## **Access Compliance Report Public Rights-of-Way** (Curb Ramps)

Intersection ID: 15444 Main Street: SOUTH BV Cross Street: RAIL CROSSING LN Location: NW **ADA ID: 6E47FF37F16B** Ramp Type: BlendTrans2 Initial Pass/Fail: Fail **Overall Compliance: No** Severity Score: 21.25

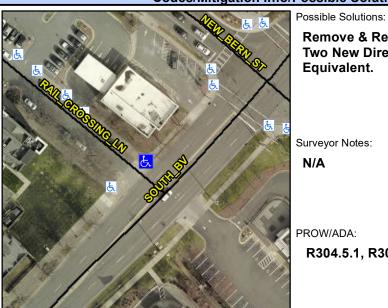
R304.5.1, R304.5.3

Comp	liance Description	Data		liance Description	Data
N/A	Ramp Length (in)	82.0	Yes	BlendTrans Slope (%)	2.7
No	Ramp Width (in)	41.0	No	BlendTrans XSlope (%)	6.9
N/A	Flare Type LT	N/A	N/A	Flare Type RT	N/A
N/A	Flare Slope LT (%)	N/A	N/A	Flare Slope RT (%)	N/A
N/A	Flare Traversable LT?	N/A	N/A	Flare Traversable RT?	N/A
N/A	Landing Length (in)	N/A	N/A	DWS Provided?	N/A
N/A	Landing Width (in)	N/A	N/A	DWS Contrast?	N/A
N/A	Landing Slope (%)	N/A	N/A	DWS Length (in)	N/A
N/A	Landing X Slope (%)	N/A	N/A	DWS Full Width?	N/A
N/A	Landing Curb? (Y/N)	N/A	N/A	DWS Offset (in)	N/A
N/A	Shared Landing?	N/A			
N/A	Gutter Ponding?	N/A	N/A	Gutter Slope (%)	N/A
N/A	Gutter Lip Ht (in)	N/A	N/A	Gutter X Slope (%)	N/A
N/A	Painted X Walk1?	No	N/A	Painted X Walk2?	N/A
	X Walk 1 Direction	To SW		X Walk 2 Direction	N/A
	X Walk 1 Width (in)	N/A		X Walk 2 Width (in)	N/A
	X Walk 1 Slope (%)	0.1		X Walk 2 Slope (%)	N/A
	X Walk 1 X Slope (%)	1.6		X Walk 2 X Slope (%)	N/A

Remove & Replace Curb Ramp With **Two New Directional Ramps or** Equivalent.
